Reply to reviewers and community comments

July 15, 2026

Figure 1: Measured vs modeled capacity factor as using different models for N_{free} compared to Simão Ferreira et al. (2026).

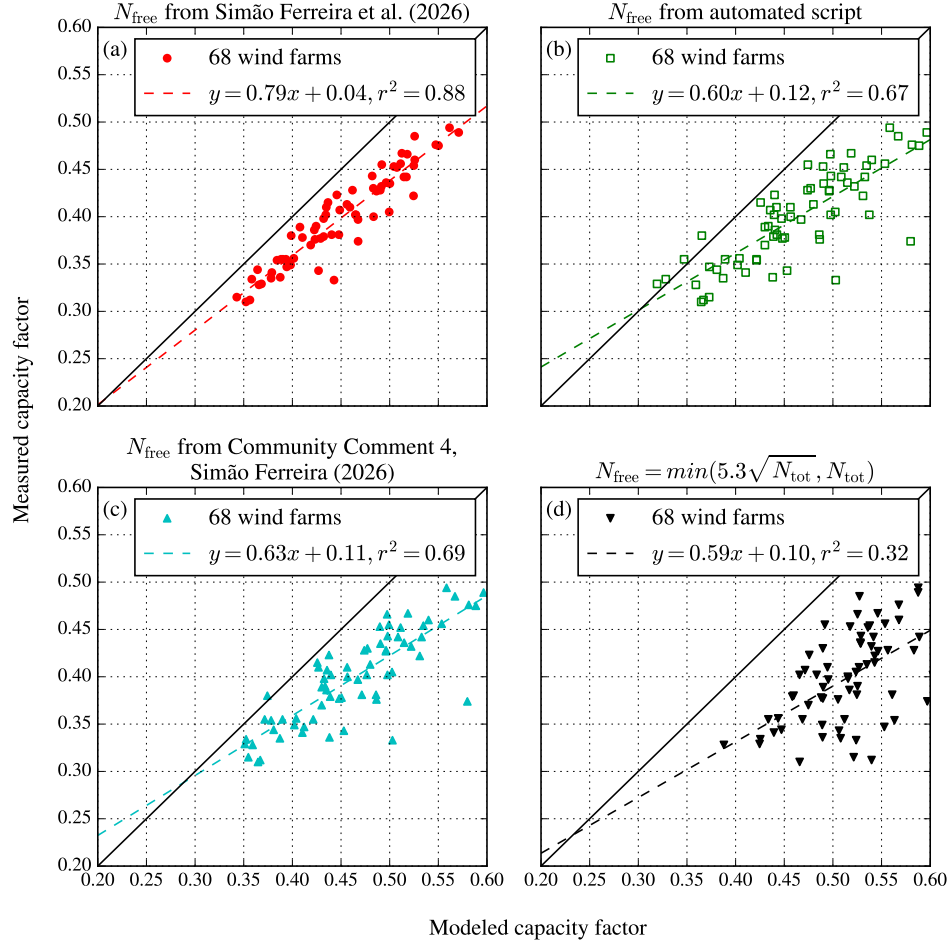
4. CC1 highlights a number of validation cases for Lillgrund, Røsand II and Horns Rev 3 offshore wind farms, showing good results (Appendix C of CC1). These are only 3 of 72 wind farms that Sørensen et al. (2026) have investigated. When modeled vs the measured wind farm capacity factor is plotted for the entire dataset using the finite wind farm correction from CC4, we do not get a good match, namely an r^2 value of 0.69, as shown in our revised comment article (Fig. 6c, also shown below in this document). Furthermore, the three wind farm results shown in CC1 are generated with an updated model (Sørensen et al. (2026)) that uses an engineering wake model database to calculate the finite wind farm factor. This is completely different from the original work of Simão Ferreira et al. (2026)).
